C03302 – Killington-Stockbridge ER STP 022-1(25)

Addendum 1

REVISED: Invitation for Bids to extend Bid Opening to December 11, 2026. Plan Sheets 5 and 30. Special Provision pages 1 and 4.

FILE NAME:	z12B234_details.dgn	PLOT DATE:	11/20/2026
PROJECT LEADER:	B.M. ROBERTS	DRAWN BY:	R.M. O'BRIEN
DESIGNED BY:	R.M. O'BRIEN	CHECKED BY:	C.K. FORD
SHOULDER WIDENING DETAIL SHEET 1		SHEET	30 OF 246

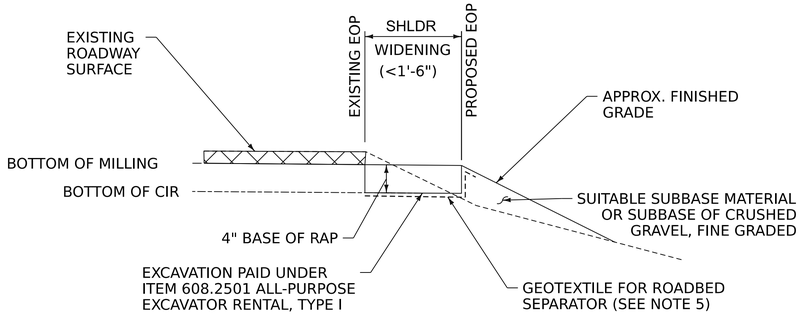
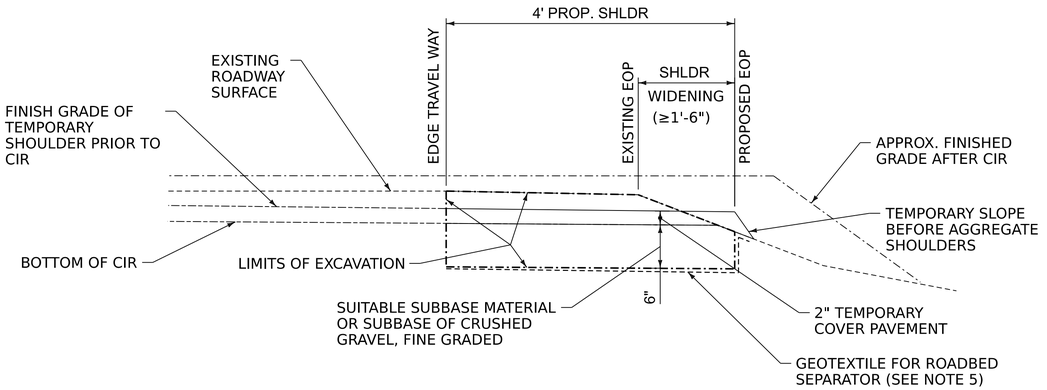
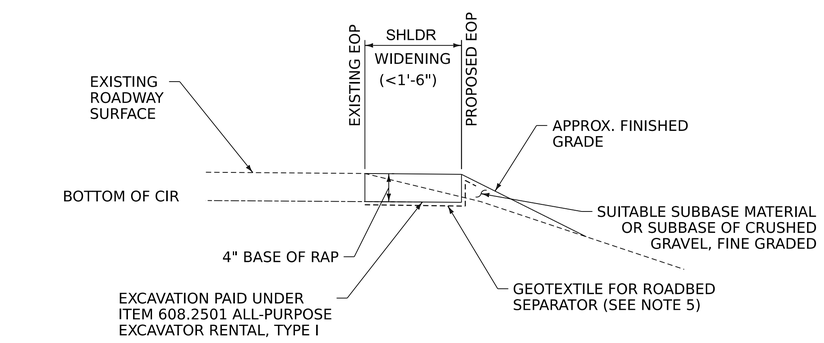
5. AN ESTIMATED QUANTITY OF ITEM 649.1100 "GEOTEXTILE FOR ROADBED SEPARATOR" HAS BEEN INCLUDED FOR LOCATIONS ~~HERE~~ WHERE UNSUITABLE MATERIAL IS FOUND IN SHOULDER RECONSTRUCTION AREAS. ~~LCOATIONS TO BE APPROVED BY ENGINEER.~~ IN LOCATIONS OF MINOR SHOULDER WIDENING WHERE GEOTEXTILE IS DEEMED NECESSARY, THE CONTRACTOR SHALL OVER EXCAVATE TO INSTALL THE GEOTEXTILE 2" BELOW THE BOTTOM OF CIR. THE ADDITIONAL 2" OF EXCAVATION WILL BE PAID UNDER ITEM 608.2501 "ALL-PURPOSE EXCAVATOR RENTAL, TYPE I" AND THE ADDITIONAL 2" OF FILL WILL BE PAID UNDER ITEM 301.4000001 "BASE OF RAP".

ADDENDUM	REV.	DATE	DESCRIPTION	BY
1	1	11/20/2026	REVISED NOTE #5	VHB
